SAVANNAH HISTORIC DISTRICT BOARD OF REVIEW

REQUEST FOR CERTIFICATE OF APPROPRIATENESS

MPC File No.: 25-005674-COA

Address: 402 East Broughton Street

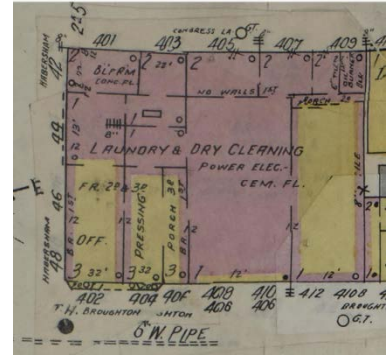
The existing building was approved for demolition at the September 2025 HDBR meeting. It was built in 1966 and received a new façade in 1985. It is located on the northeast corner of Broughton and Habersham Streets. The one-story concrete block building has plate glass windows and a cantilevered awning. It housed Southern Motors for several years.

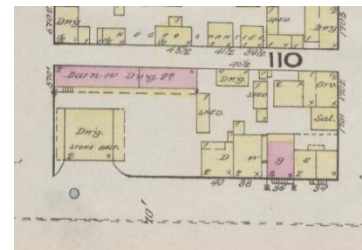
As it relates to vehicular access (§7.8.10.r.ii), based on the Sanborn Maps (at the right) access was present in 1884. By 1916, the corner was a Laundry and Dry Cleaning business. The business was a mix of 3 stories on the corner and one story on the interior. A historic photo (below) from 1940 clearly shows multiple curb cuts/aprons in

front of the business. By the time that Southern Motors was built on Broughton Street, ca. 1951-1966, there was access to the car lot from Broughton Street. With this information, it can be assumed that vehicular access has been present intermittently for at least 142 years and more recently on a daily basis for the last 50 plus years. Continued use of this driveway/apron would not be detrimental to

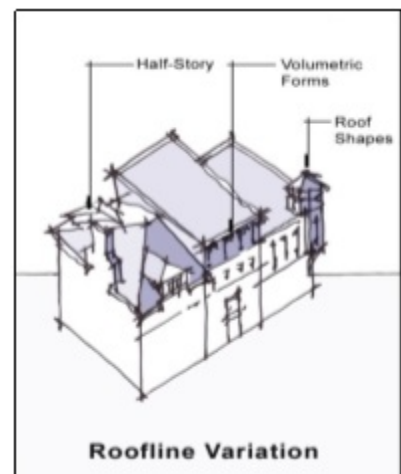
The applicant has a fourth story penthouse which is setback from the front façade. The penthouse has limited visibility and per the figure to the right, the roofline variation should be visible along the street frontage. To address this concern, the applicant has redesigned penthouse to pull the roofline to Broughton Street. They have provided two options, one (Option A) where the roof is supported two columns and a secondary option (B) that has the roof supported by a wall with punched in openings. Staff believes that Option B meets the standard.

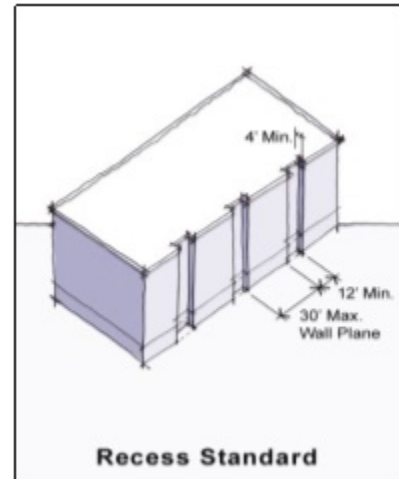
The proposed building was designed with a length of 120' along Broughton Street and 90' along Habersham Street. There are multiple columns that stand proud of the wall plane with a width of approximately 3'. In between the columns are large, recessed areas ranging from 12' to approximately 24'. The depth of each recess appears to be between 2' to 4'6". This standard is met.
